**STAFF REPORT**  
**KETCHUM PLANNING AND ZONING COMMISSION**  
**MEETING OF JULY 13, 2020**

- PROJECT:** 4<sup>th</sup> & Walnut Ave Commercial Development Design Review
- FILE NUMBER:** P20-046
- APPLICATION TYPE:** Design Review
- APPLICANT:** Graham Whipple, Resin Architecture
- PROPERTY OWNER:** Walnut & Fourth LLC
- LOCATION:** 371 & 391 N Walnut Avenue (Ketchum Townsite: Block 44: Lots 7 & 8)
- ZONING DISTRICT:** Retail Core Subdistrict of the Community Core (CC-1)
- NOTICE:** A public hearing notice for the project was mailed to all owners of property within 300 feet of the project site on June 26<sup>th</sup>, 2020. The Planning & Building Department has received no public comment as of the publication of the Staff Report. Public comment received after the Staff Report’s publication will be forwarded to the Planning & Zoning Commission and included in the project record.
- REVIEWER:** Abby Rivin, Associate Planner

**NEW MIXED-USE BUILDING AT CORNER OF 4<sup>th</sup> & WALNUT**

RENDERINGS

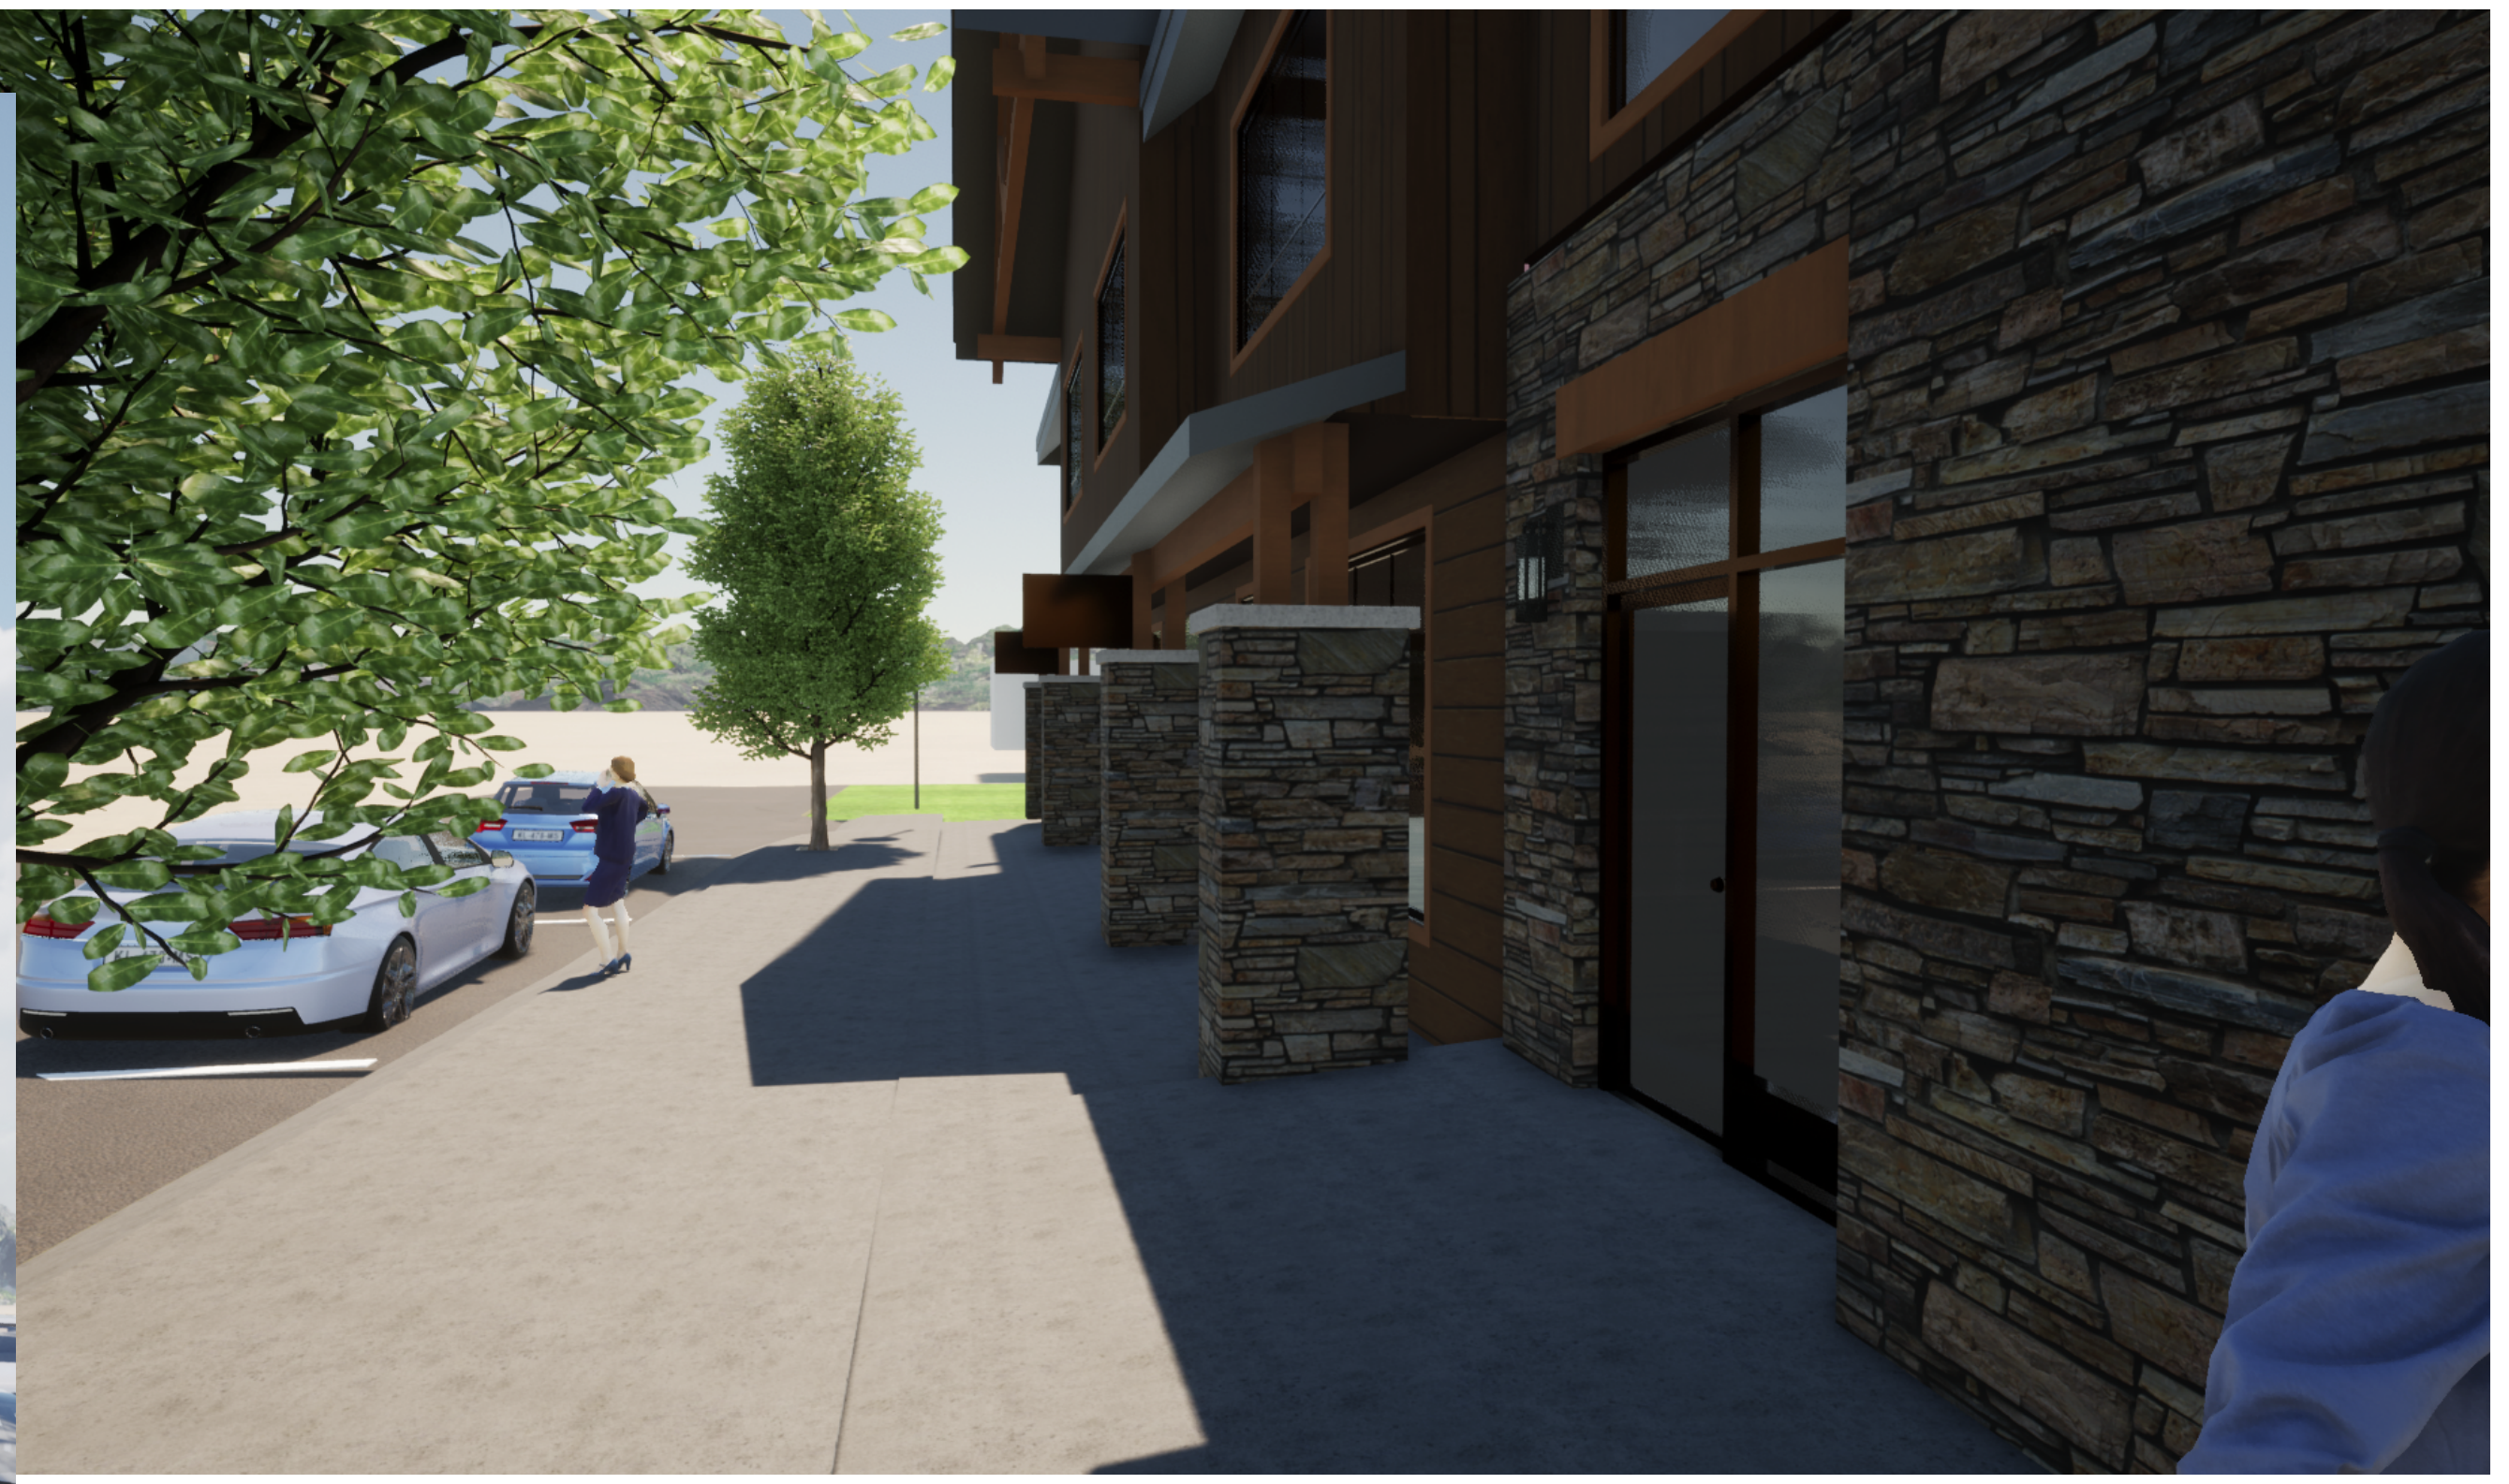
- Renderings that illustrate the front, side, and rear façades; and  
*The renderings indicated on Sheets A301 and A302 of the project plans illustrate views the 4<sup>th</sup> Street, Walnut Avenue, and street corner elevations. Renderings illustrating the entire surface area of each façade will further emphasize each façade's undulation, articulation, and material differentiation.*
- Colored elevations specifying the building's exterior materials.
